ADDENDUM NUMBER 5

**PROJECT: SHELBY COUNTY JAIL EXPANSION
FOR THE SHELBY COUNTY COMMISSION
COLUMBIANA, ALABAMA
GMC PROJECT NO. AMGM220005
Local Funds**

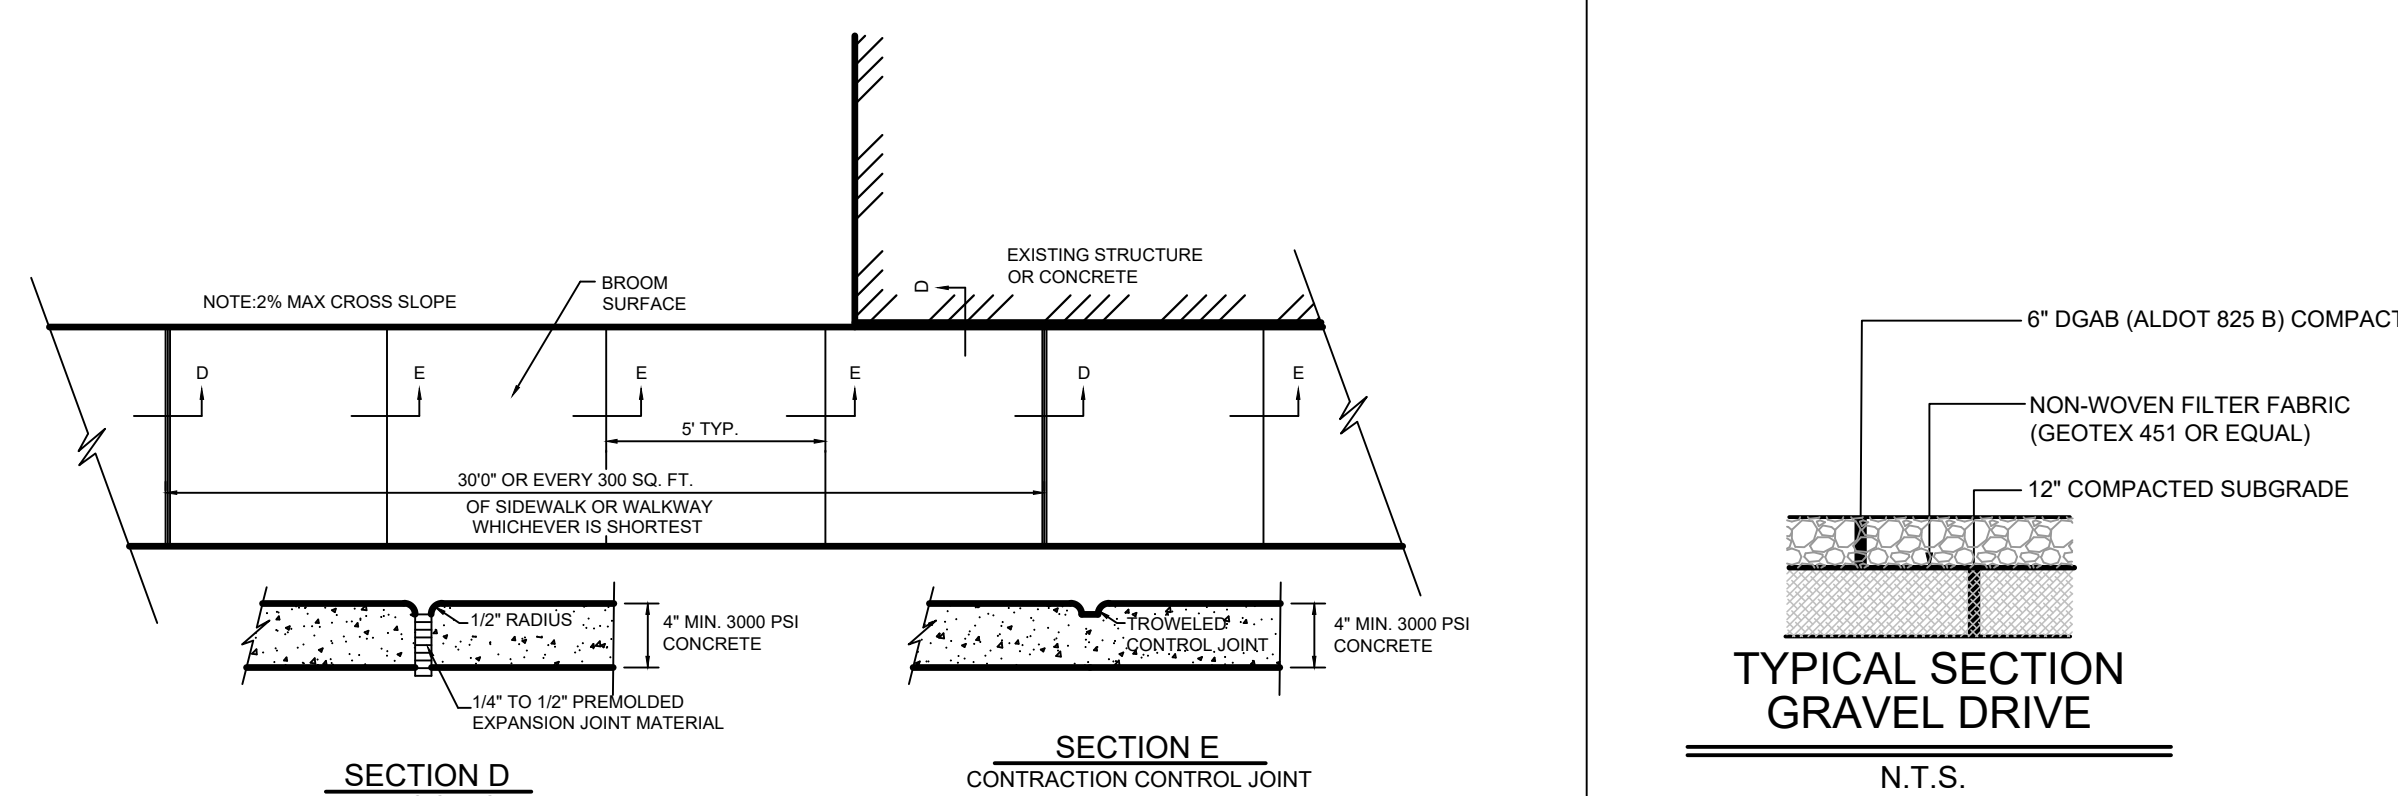
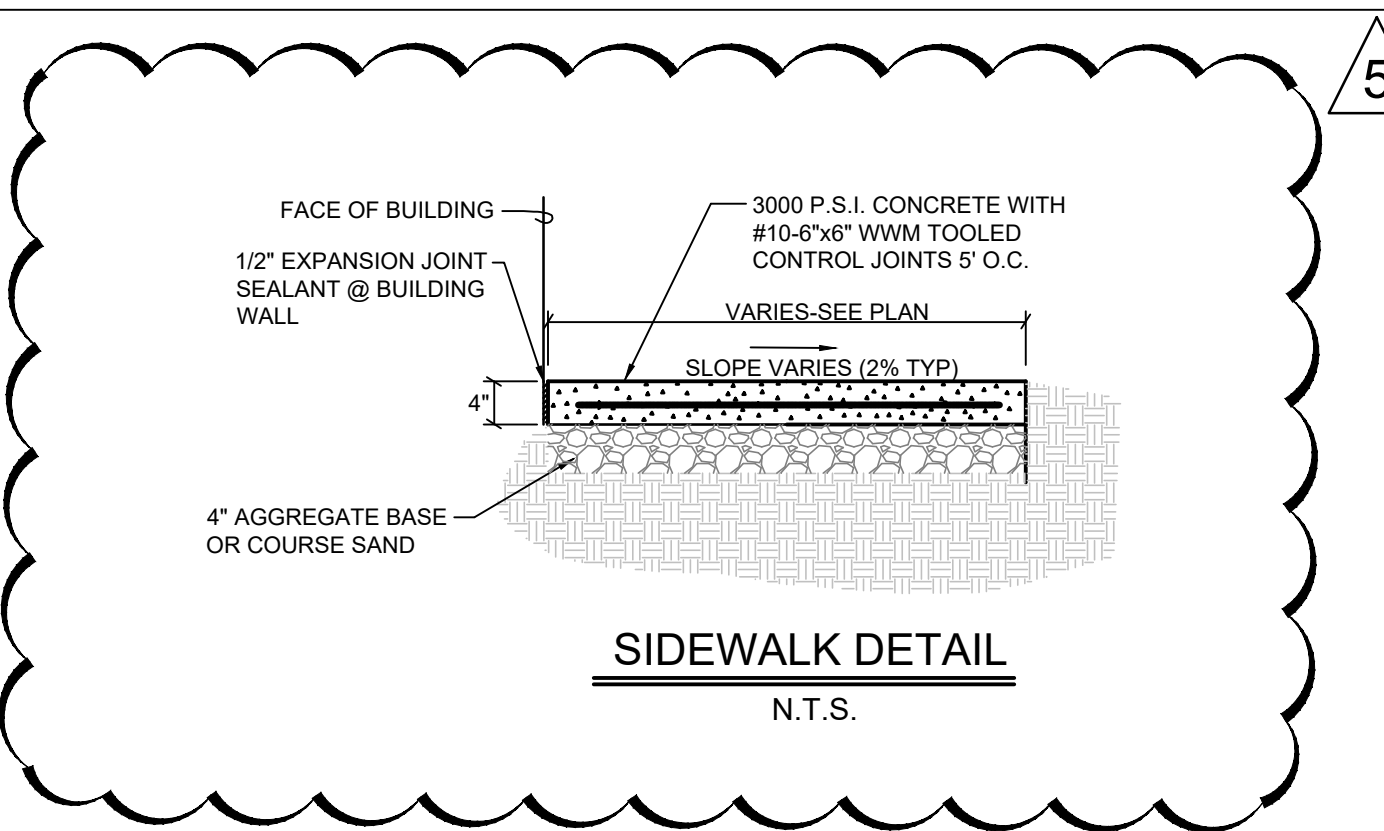
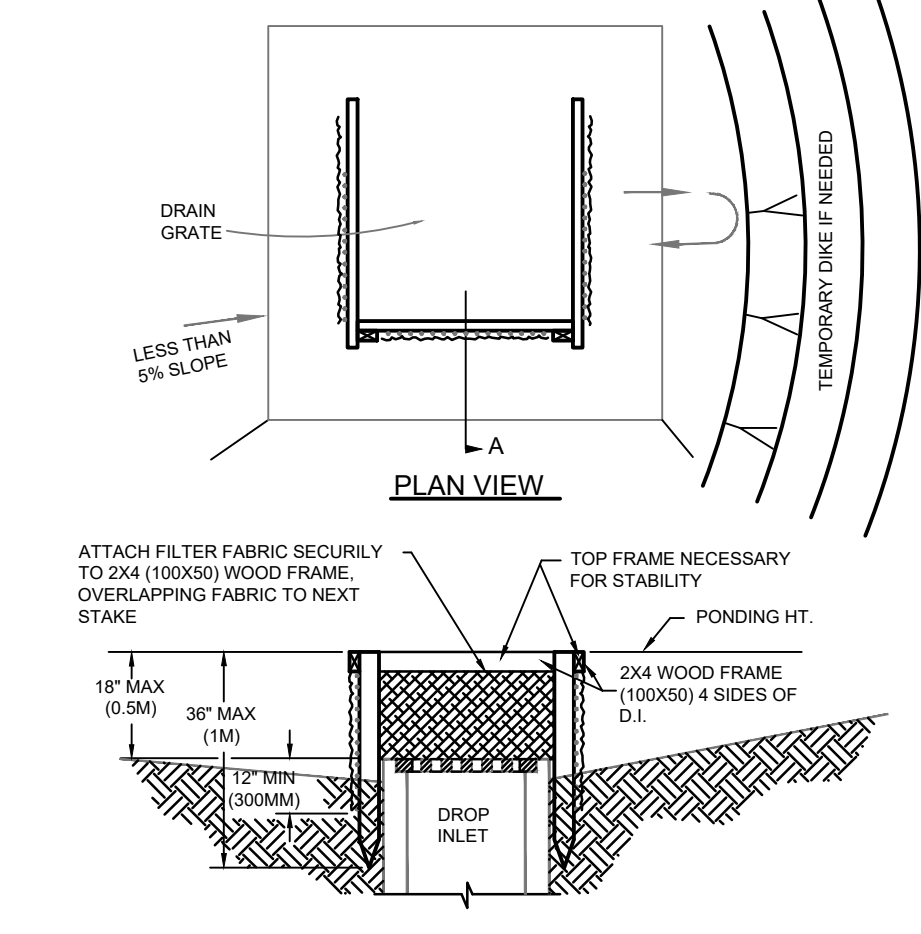
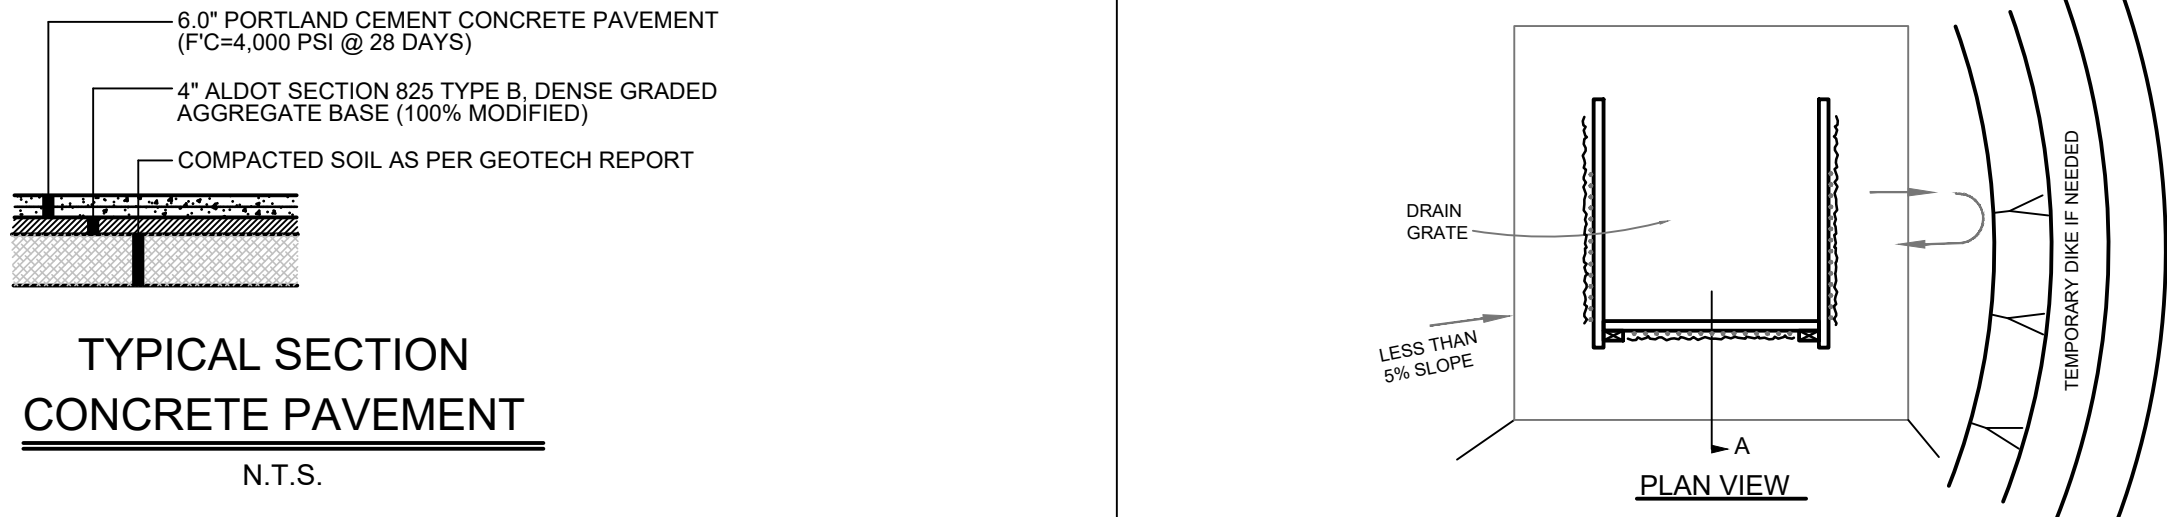
- A. C401 – CONSTRUCTION DETAILS
 - a. Replace the sheet in its entirety to revise the sidewalk thickness to four inches
- B. A901 – DETENTION DOOR SCHEDULE
